BULLETIN NUMBER:  
**SB13-J-001**

**CRACKED TURBOCHARGER VACUUM SWITCHING VALVE (VSV) VACUUM HOSE  
RELATED DTCs: P0299, P2263, P2456, P2413**

- 2011-2012MY Isuzu N-Series  
Equipped with 3.0L 4JJ1 Diesel Engine

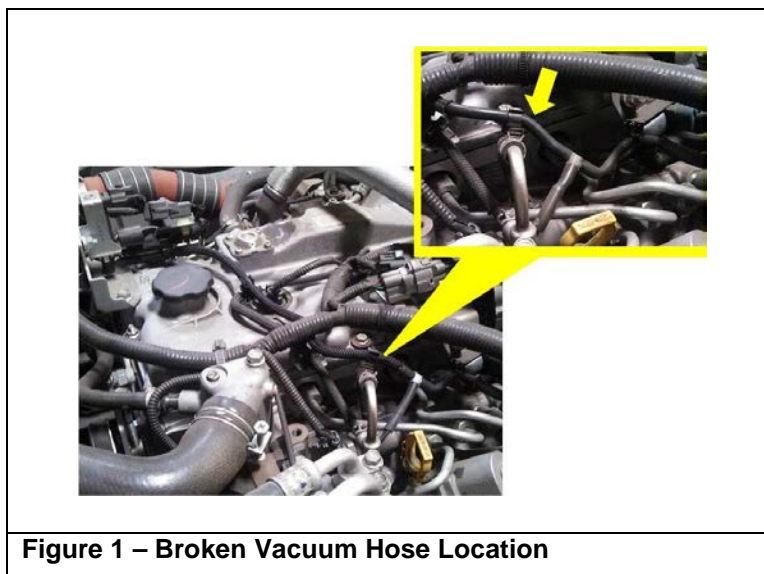
The vacuum hose for the Turbocharger Vacuum Switching Valve (VSV) may crack at the clip location shown in Figure 1.

If the above cause is found, follow the service procedure in this bulletin to replace the vacuum hose assembly.

**NOTE:** Do not use bulk hose material for the countermeasure. The new hose assembly has been redesigned to offer additional reinforcement.

**Figure 2 – Removal of Vacuum Hose**

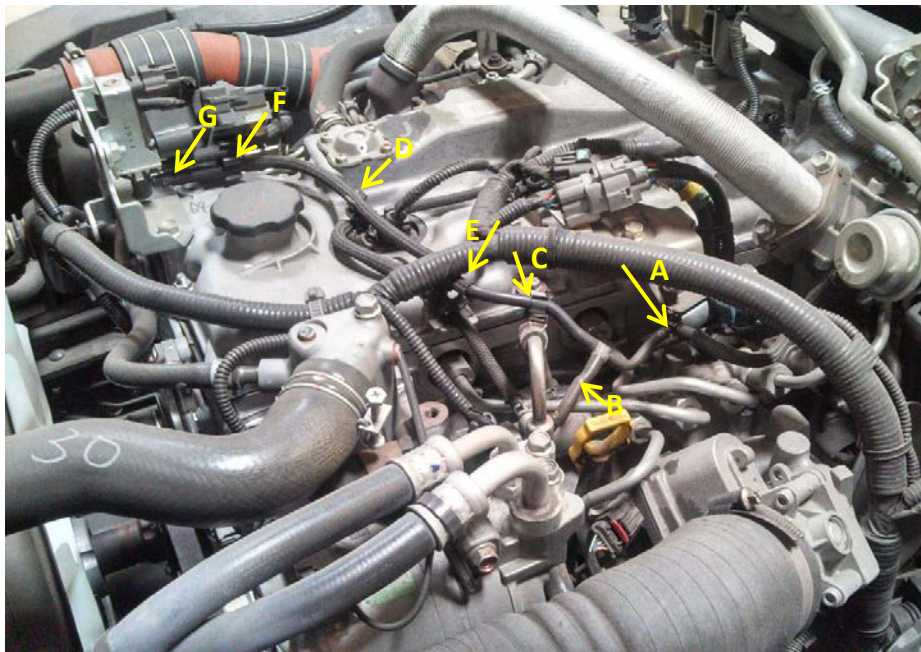
1. Remove the vacuum hose assembly below in the following order:
  - a. Vacuum Supply Pipe
  - b. EGR Bypass Vacuum Switch Valve (VSV)
  - c. Retaining Clip
  - d. Hose with Retaining Clip
  - e. Clip
  - f. Turbo Charger Actuator
  - g. Turbo Charger VSV (2 hoses)

**NOTE:** Do not use bulk hose material for the countermeasure. The new hose assembly has been redesigned to offer additional reinforcement.

2. Install the replacement hose in the following order:
